Project Number: SP2018-007
Project Name: Starbucks
Project Type: SITE PLAN
Applicant Name: MOORE WORTH INVESTMENTS, LLC
Owner Name: MOORE WORTH INVESTMENTS, LLC
Project Description:

City of Rockwall Project Plan Review History

Project Number SP2018-007	Owner MOORE WORTH INVESTMENTS, LLC	Applied 3/13/2018 LM
Project Name Starbucks	Applicant MOORE WORTH INVESTMENTS, LLC	Approved
Type SITE PLAN		Closed
Subtype		Expired
Status Staff Review		Status

**CITY OF ROCKWALL
PLANNING AND ZONING COMMISSION MEMO**

1 SITE PHOTOMETRICS
 SCALE: 3/32" = 1' - 0"

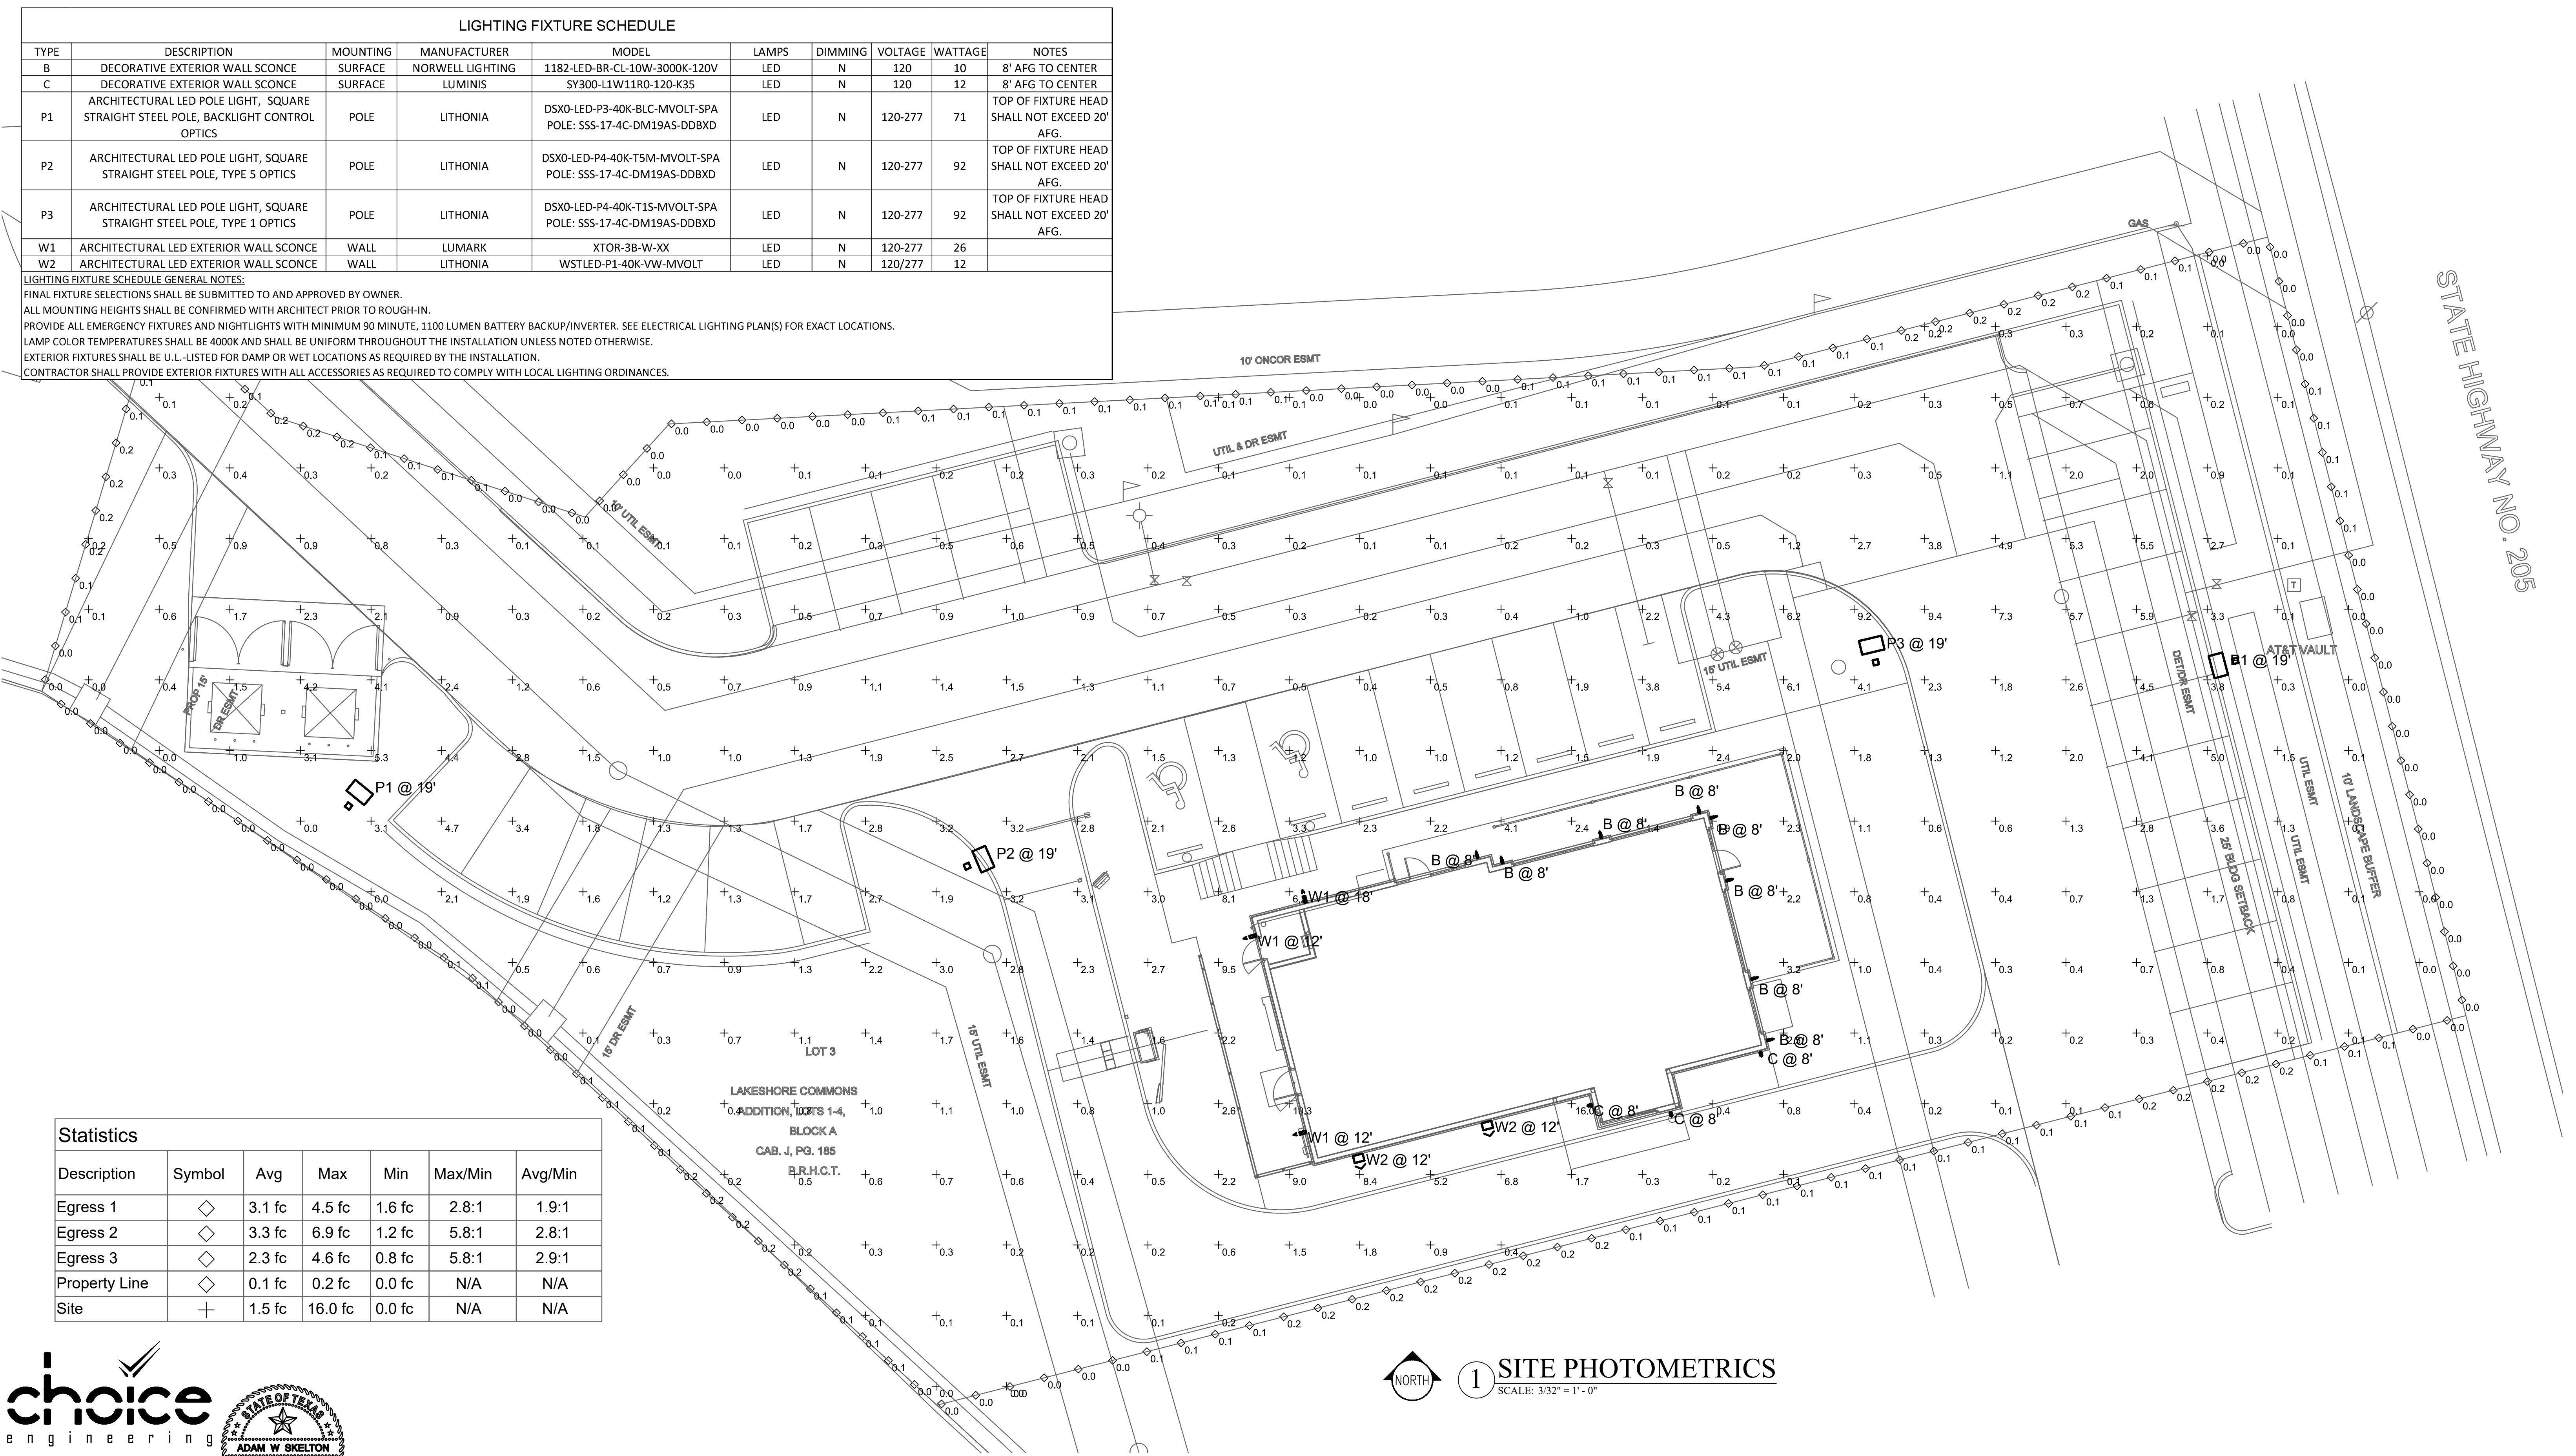
M.22						Landscape Plan. Please note that canopy trees are a min of 4 caliper-inches and not 3-3.5 caliper-inches as shown.
M.23						Landscape Plan. Please note that the LS buffer is 20-feet not 10-feet.
M.24						Photometric Plan. Please darken property line on photometric plan.
M.25						Photometric Plan. Please provide some clarification on the symbols for "Egress 1, 2, 3, and Property Line"
M.26						Photometric Plan. Please label cut sheet so that I can determine which cut sheet matches the fixture type on the photometric plan.
M.27						Photometric Plan. Please note that any light over 15-watts shall be directed downward with a partial or full cutoff
M.28						Photometric Plan. Please provide site data table as shown in site plan.
M.29						Photometric Plan. Please show centerline of SH-205
M.30						Building Elevations. Please note that the overlay district requires 8-foot dumpster enclosure. Please provide elevations of dumpster enclosure.

01 FRONT (EAST) ELEVATION

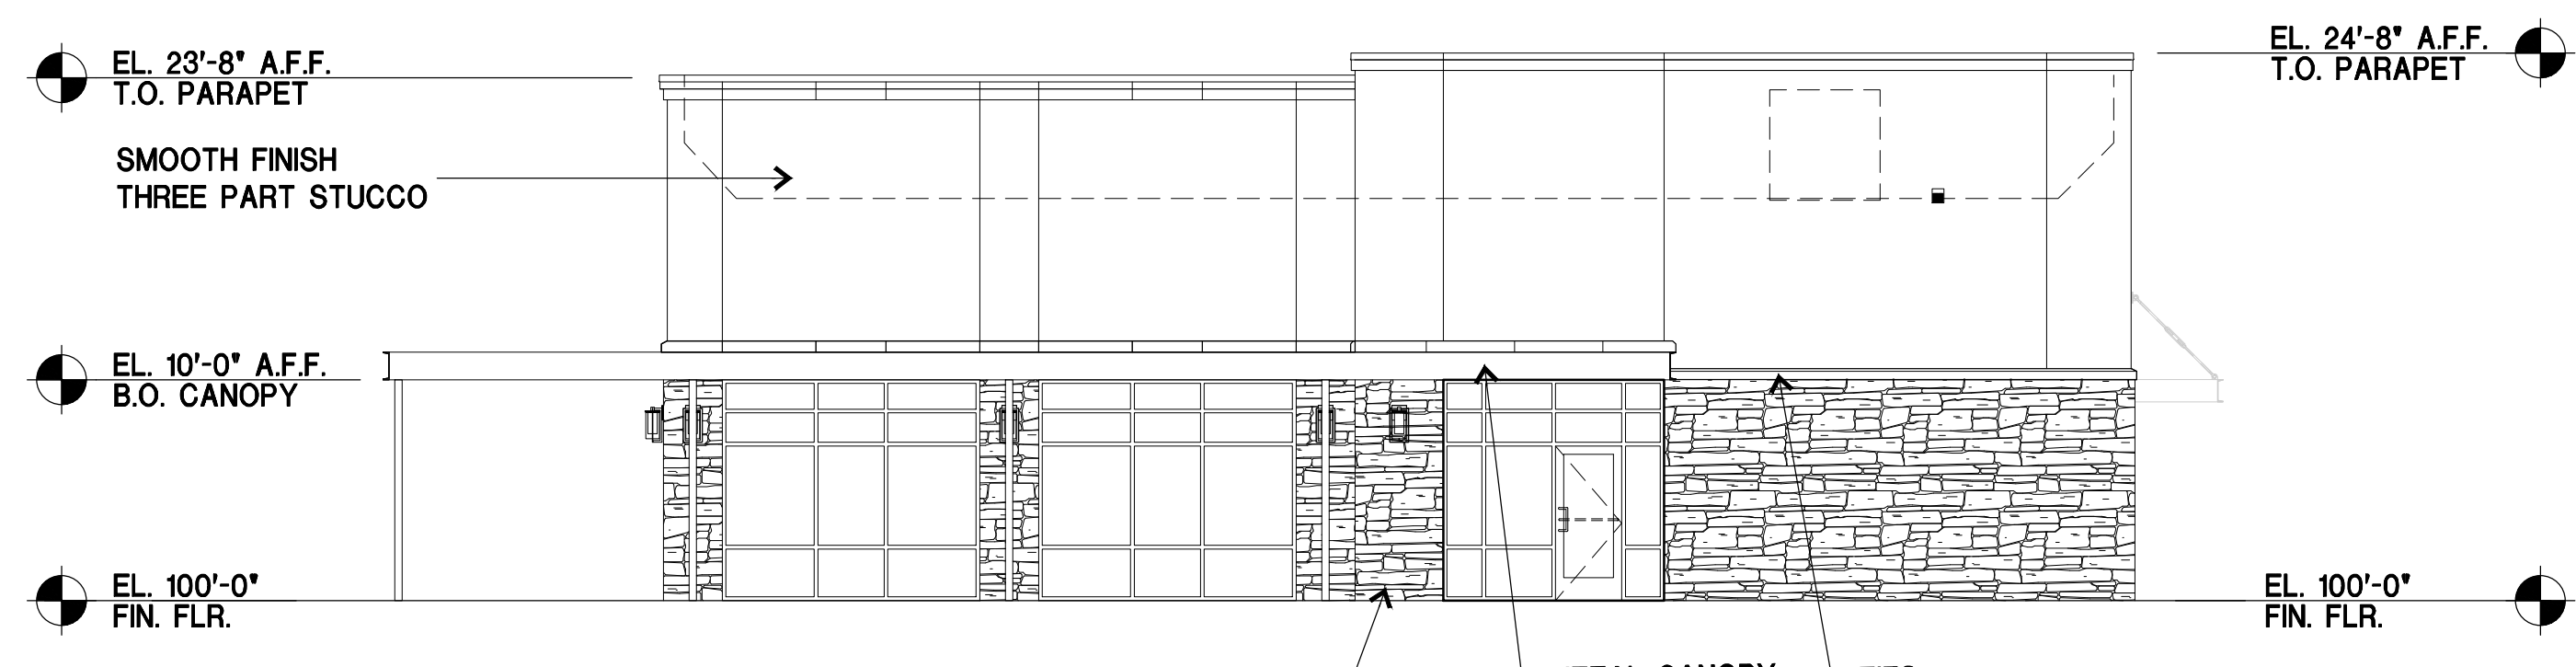
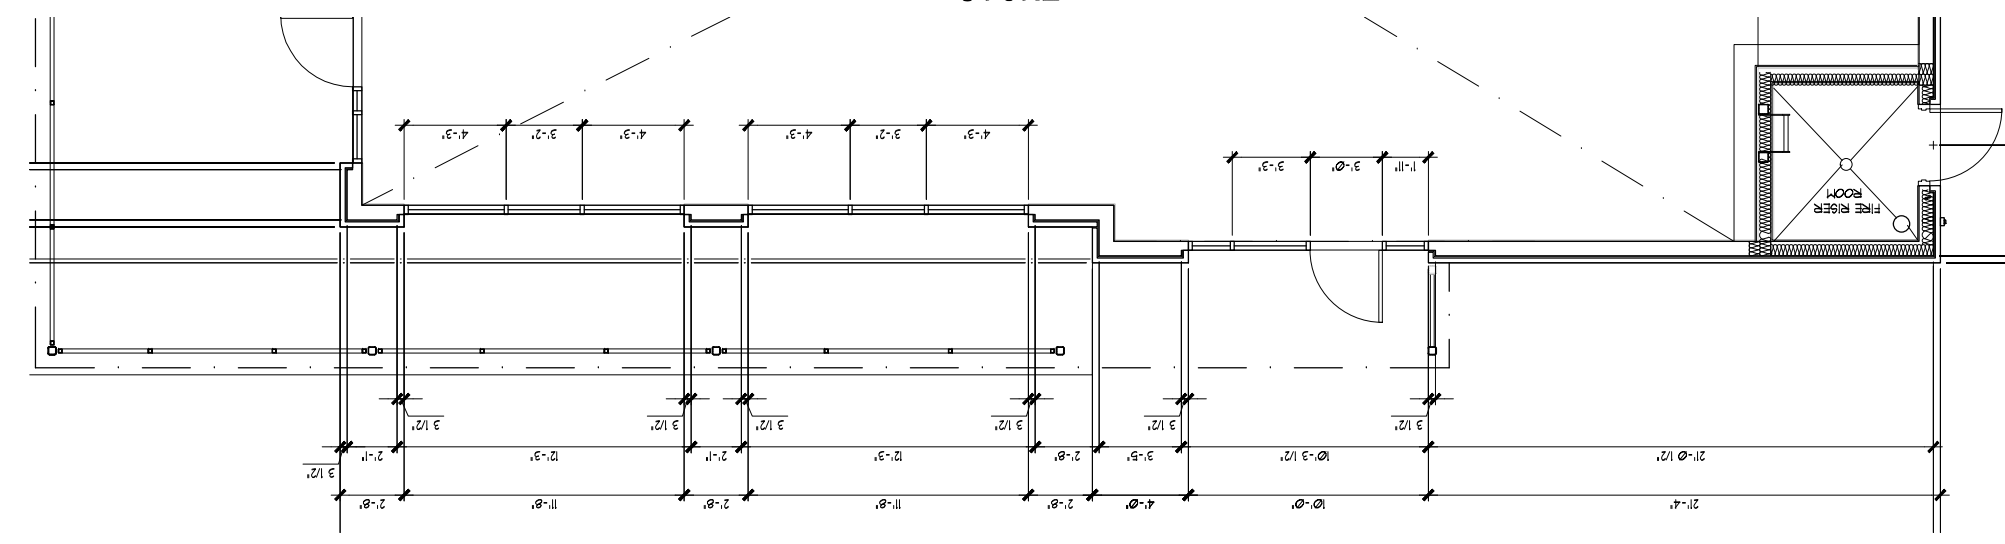
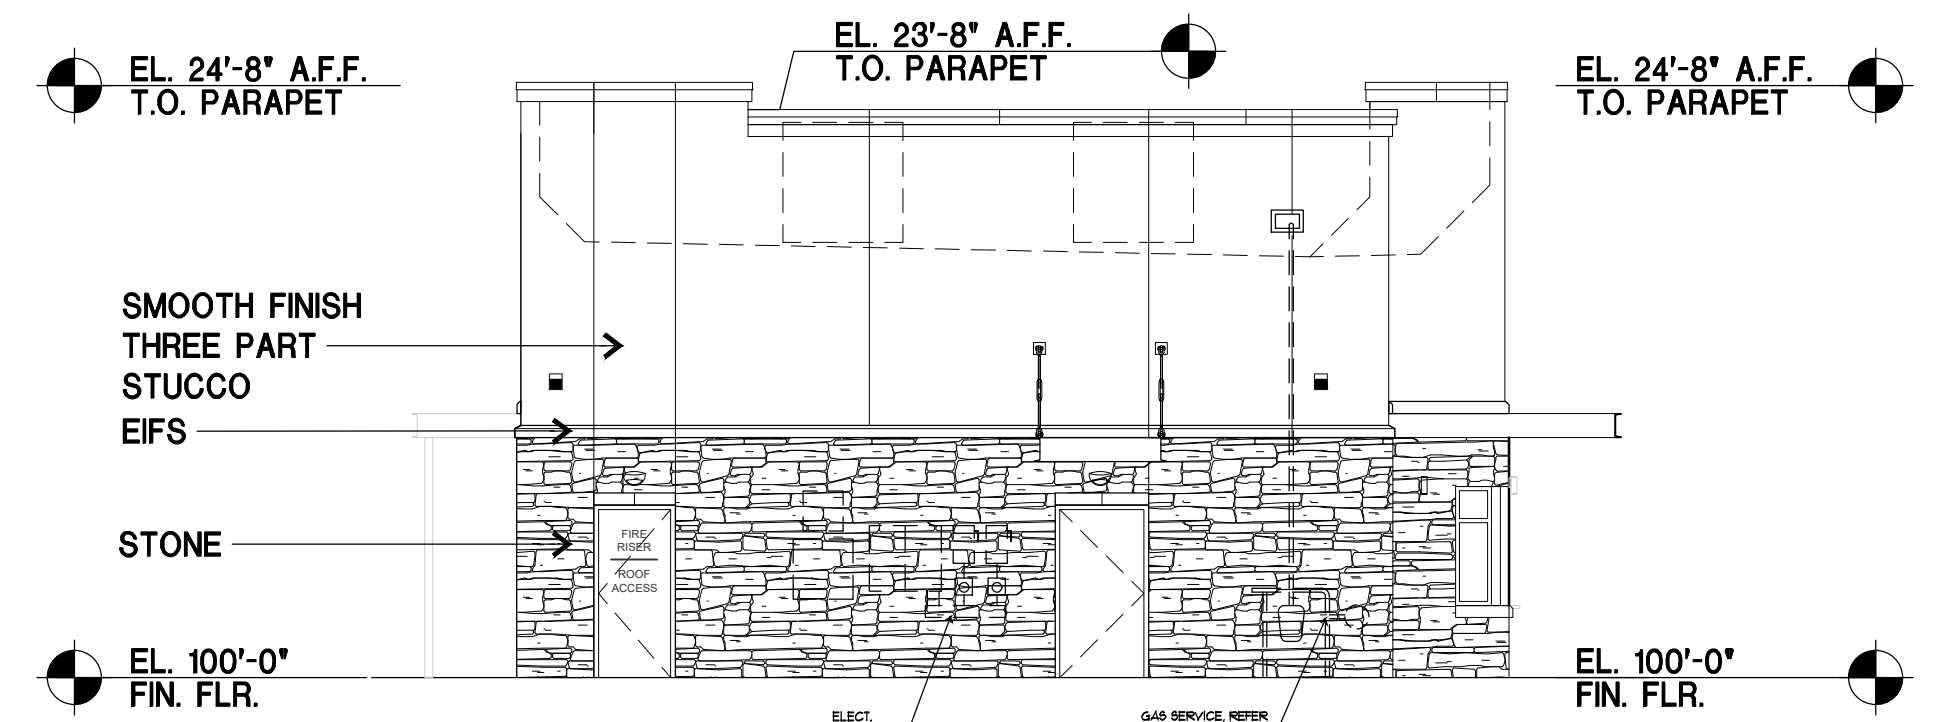
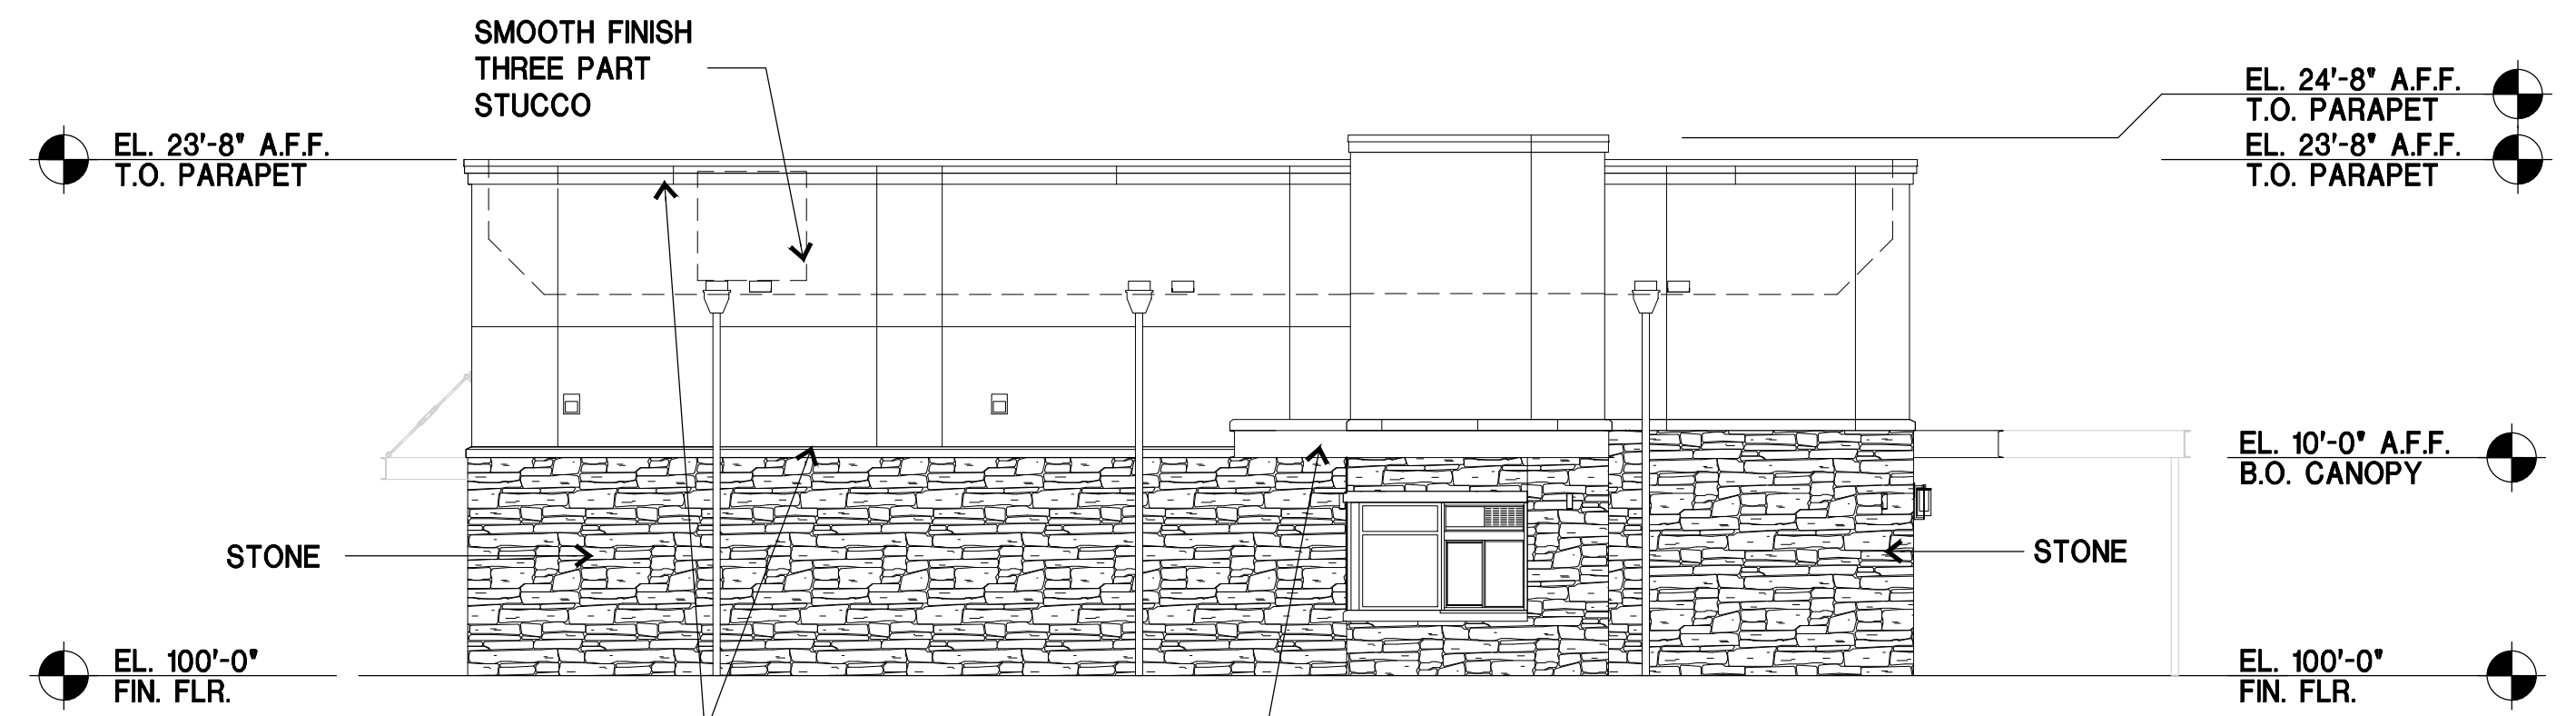
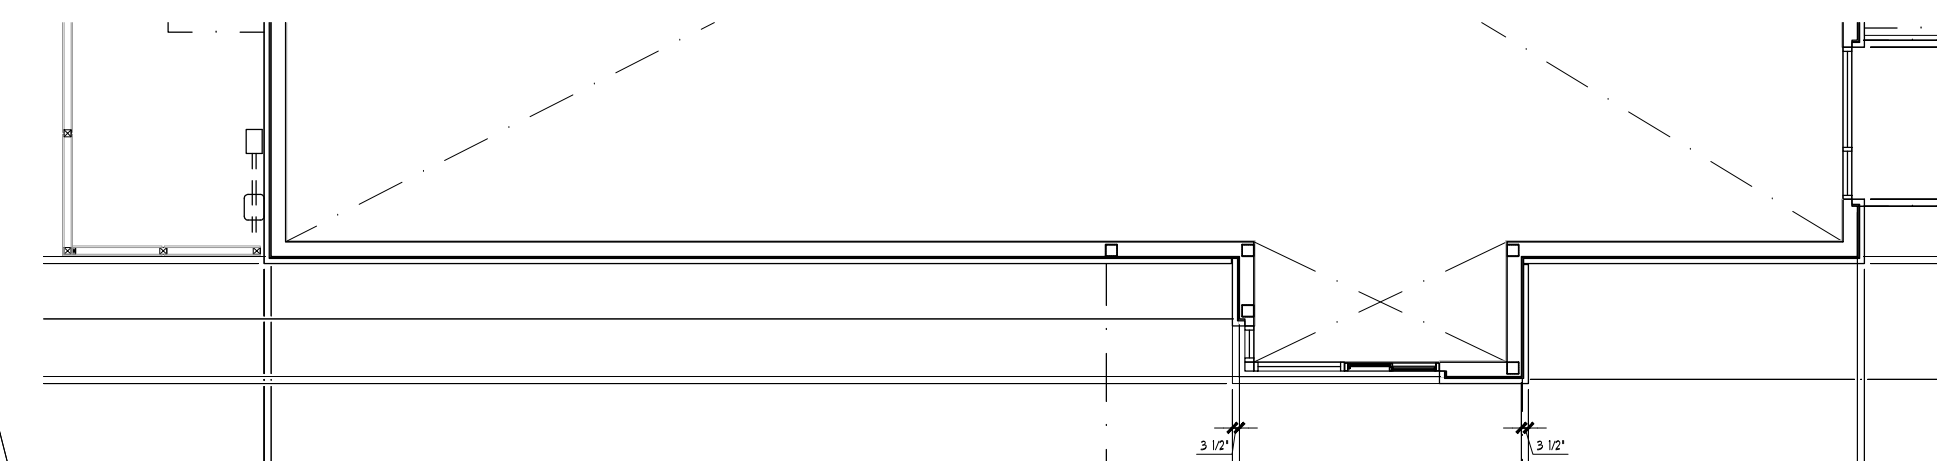
M.31						Building Elevations. Please note in an overlay district, natural or quarried stone is required. You are proposing cultured stone which would require approval of a variance.
M.32						Building Elevations. Please remove metal canopies from building façade material percentages and re-calculate.
M.33						Building Elevations. Please note that EIFS is a secondary material. Secondary materials over 10% per façade require a variance.
M.34						Building Elevations. Please indicate the elevation that faces the street.
M.35						Building Elevations. Note that stucco over 50% per façade will require a variance.

Type of Review / Notes	Contact	Sent	Due	Received	Elapsed Status	Remarks
M.36	Building Elevations.					Please note that this will require a variance to the pitched roof requirement. According to the UDC, any building less than 6,000 SF shall be constructed of a pitched roof system.
M.37	Building Elevations.					Please provide a materials sample board.
M.38	Building Elevations.					If the building elevations are scalable, please provide scale.
I.39	The Architectural Review Board (ARB) meeting for this case will be held on March 27, 2018 at 5:00 p.m.					
I.40	Staff has identified the aforementioned items necessary to continue the submittal process. Please make these revisions and corrections, and provide any additional information that is requested. Revisions for this case will be due on April 3, 2018. The Planning and Zoning Worksession for this case will be March 27, at 6:00 p.m. The Planning and Zoning Meeting will be April 10, 2018. A representative is required to attend all meetings.
